**ADDENDUM NO. 2  
REQUEST FOR TENDER No. Doc4733675736  
CONTRACT No. 24-PFR-098**

**FOR: HVAC AND STRUCTURAL STATE OF GOOD REPAIR PROJECT AT ELMS POOL**

**POOL HEAT RECOVERY CONNECTION**

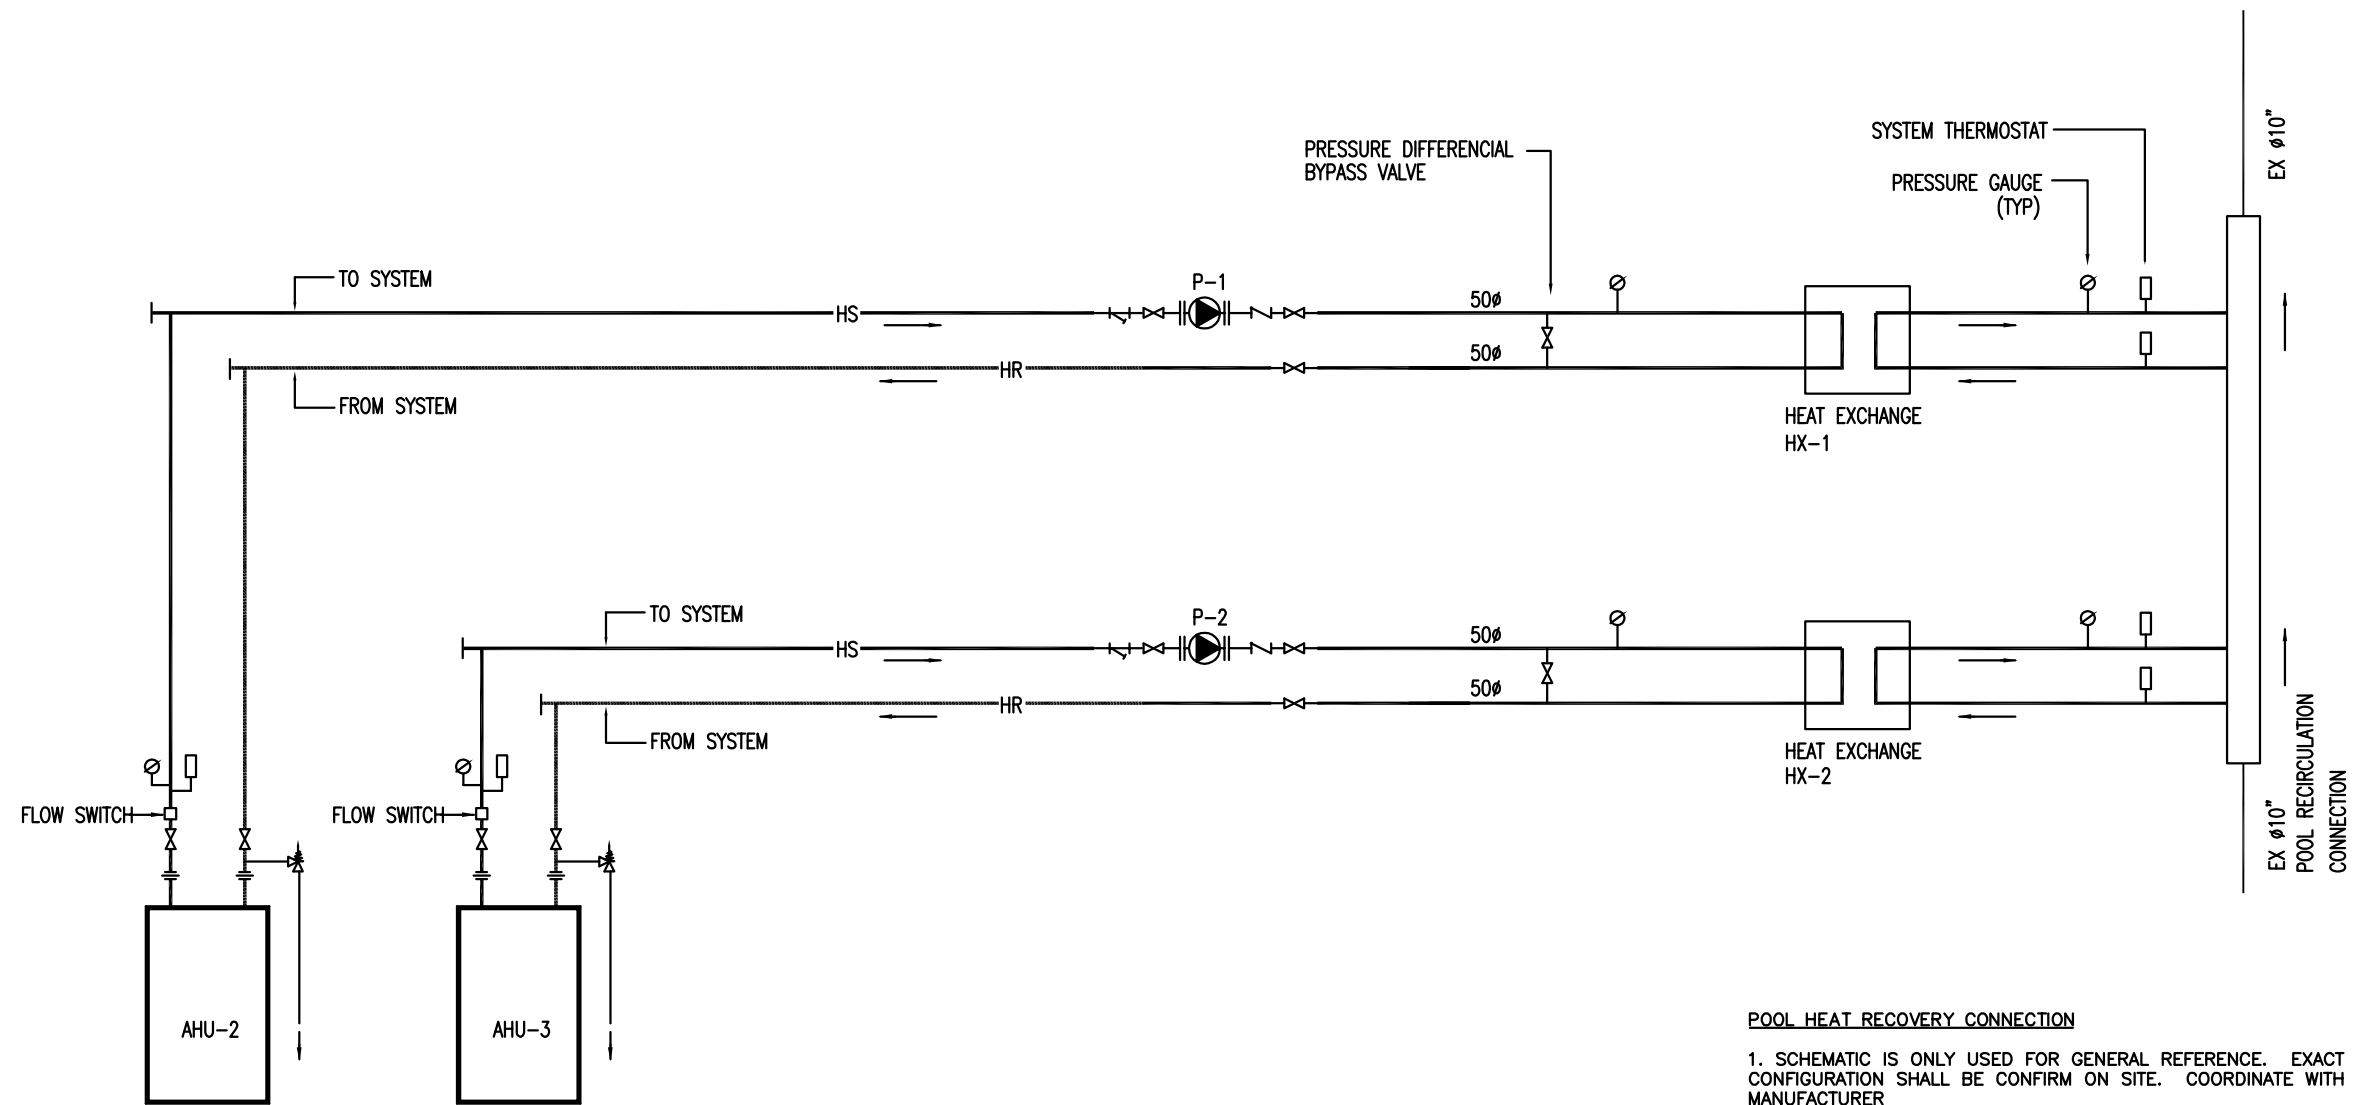
1. See attached enclosed partial drawing, M7, detail #5 (pool recovery connection).

**Q5. Please provide the drawing for the piping connection for the heat recovery system of two AHU. Model number of the heat exchangers. Are valve and pump required for the heat recovery system?**

A5. Refer to the enclosed partial drawings M7, detail #5 for all components required for the heat recovery system.

1. SCHEMATIC IS ONLY USED FOR GENERAL REFERENCE. EXACT CONFIGURATION SHALL BE CONFIRM ON SITE. COORDINATE WITH MANUFACTURER
2. PROVIDE TWO 2" RE-CIRCULATION PIPES (XFR) FROM EACH UNIT TO NEW HEAT EXCHANGER SUITABLE FOR POOL WATER (CHLORINE)

3. PIPE SHALL FOLLOW EXISTING ROUTE. APPROX 100' FROM AHU TO POOL CONNECTION
4. PROVIDE TWO NEW HEAT EXCHANGERS (HX-1, HX-2). LOCATED IN LOWER BASEMENT  
TWO HEAT EXCHANGERS SHALL BE T-CONNECTED ON THE OUTPUT SIDE TO EXISTING POOL HEATING SYSTEM WITH ISOLATION VALVES.

5. PROVIDE ALL NECESSARY ISOLATION VALVES, THERMOSTATS AND PRESSURE GAUGES, PIPES, COUPLES, BRACKETS TO COMPLETE CONNECTION
6. HEAT EXCHANGER (HX-1 & HX-2): PLATE (10"X20"X6"D), COPPER/ZINC COATED, MANUFACTURER ZURN

7. RECIRCULATION PUMPS (P1 & P2): 1/2HP, 120V,1P, 5.2A, CONINUOUS OPERATION, THERMO PROTECTED, MANUFACTURER: BELL & GOSSETT - M80067 SERIES  
PROVIDE TWO 120V,15A,1P CIRCUIT (AWG 2#12) FROM HOUSE PANEL

8. EXISTING UNUSED PIPING SHALL BE REMOVED.
9. PIPE ROUTING SHALL FOLLOW EXISTING AND SPECIFIED ROOF OPENS.
